# 1984 Corvette: Service Bulletin: Side Door Lateral Movement

**Source:** Chevrolet Dealer Service Bulletin

**Bulletin No:** 84-118, Section: 10 (I)

**Date:** April, 1984

FIGURE 1

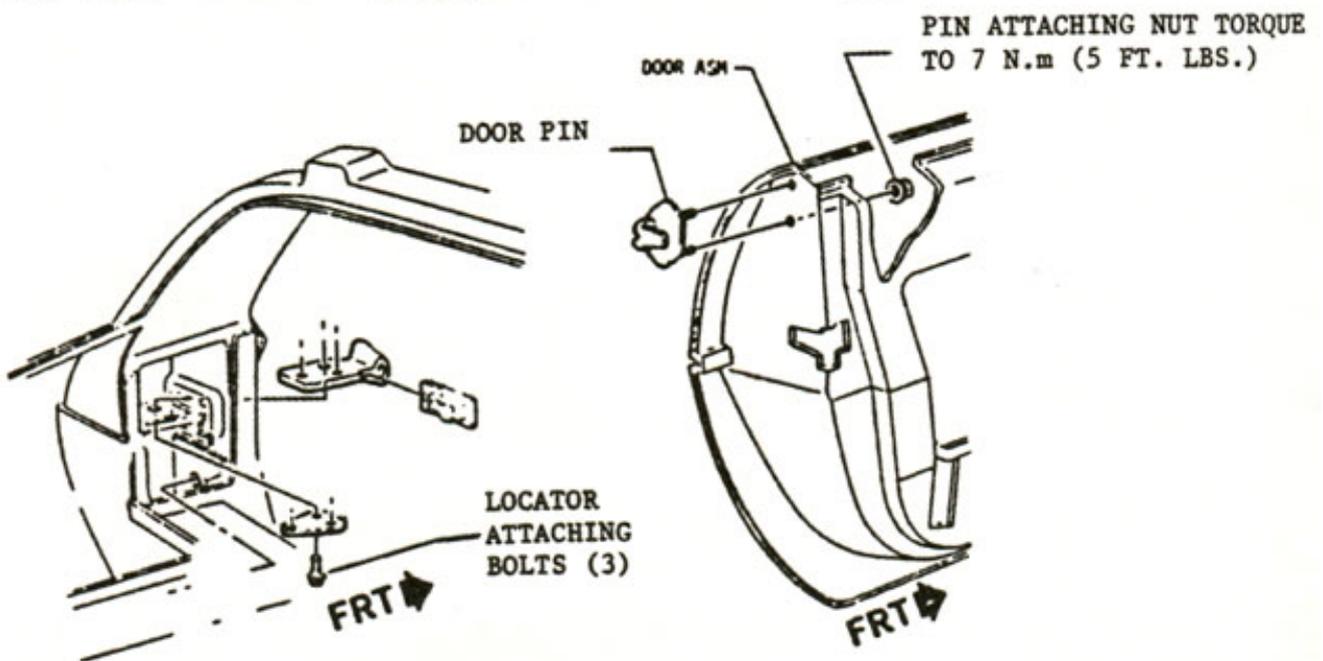
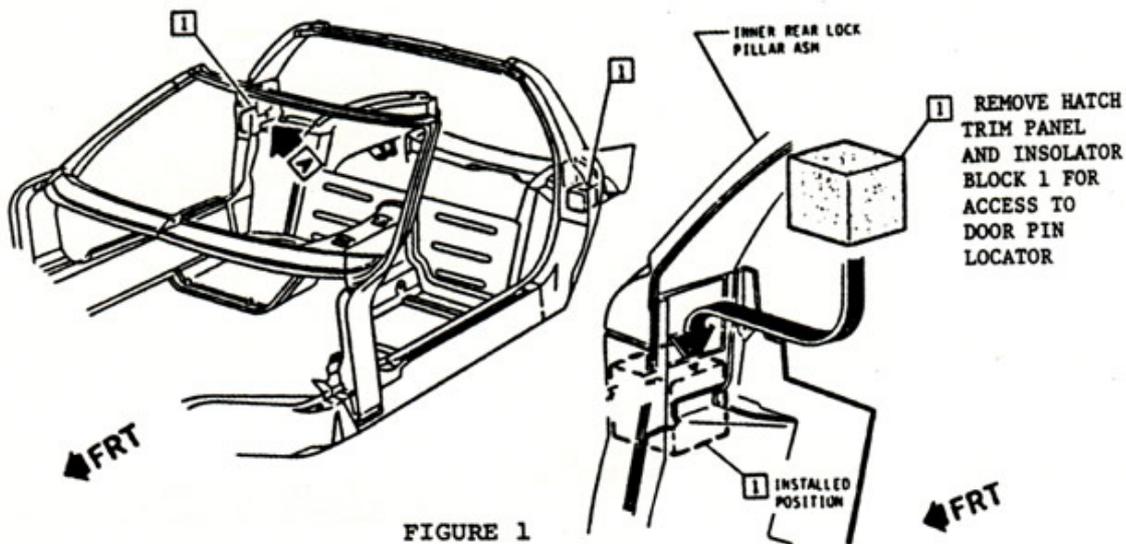
Verify the plastic sleeve is installed in the pin locator assembly. With the vehicle door closed, loosen the locator three (3) attaching bolts (see Figure 1). The locator assembly is to be centered fore-aft and vertically on the door pin. Push the locator outboard to fully engage the door pin and tighten the locator attaching bolts to 11 N.m (8 ft. lbs.)

FIGURE 2

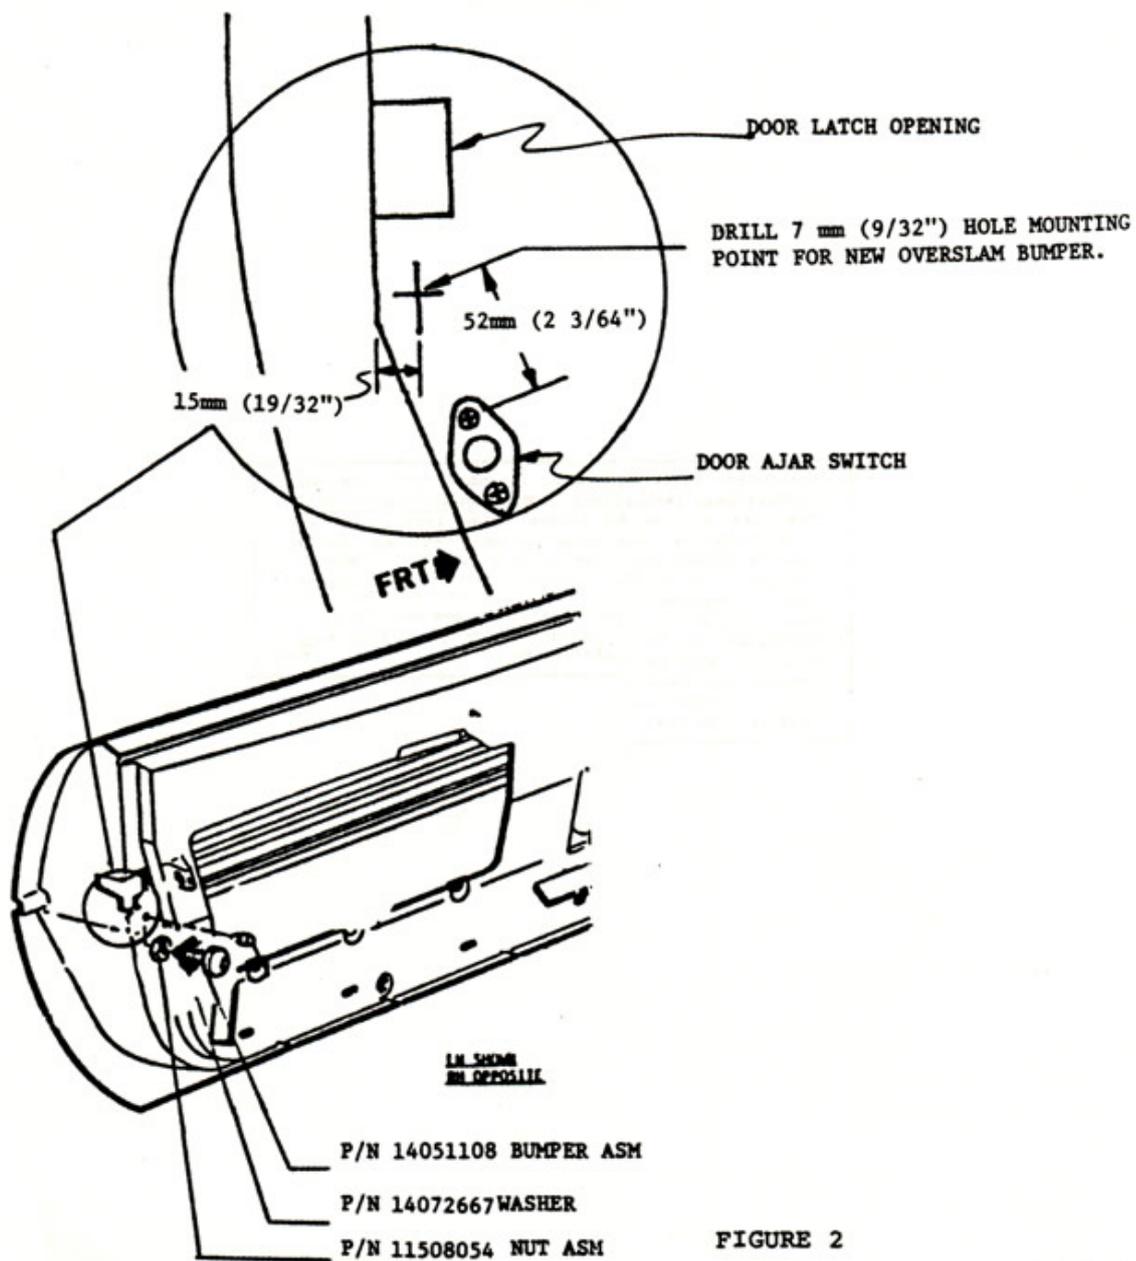
Some early built vehicles did not have overslam bumpers. if this is the case, it will be necessary to drill a 7mm (9/32") hole in the door (see Figure 2).

Add shims (washers) between bumper and door, as required, to eliminate lateral door movement (see Figure 2). DO NOT "OVERSHIM" BUMPER.

Replace the discarded production bumper(s) with bumper, P/N 14051108, attaching nut, P/N 11508276, and P/N 14072667, flat washers, which are to be used as bumper shims. The number of shims required will vary form vehicle to vehicle depending on "Build stacks".

Once shim pack has been established, tighten bumper retaining nut to 12 N.m (9 ft. lbs.) and check the door ajar lamp for proper operation. The door ajar switch is self-adjusting and cannot be reset.
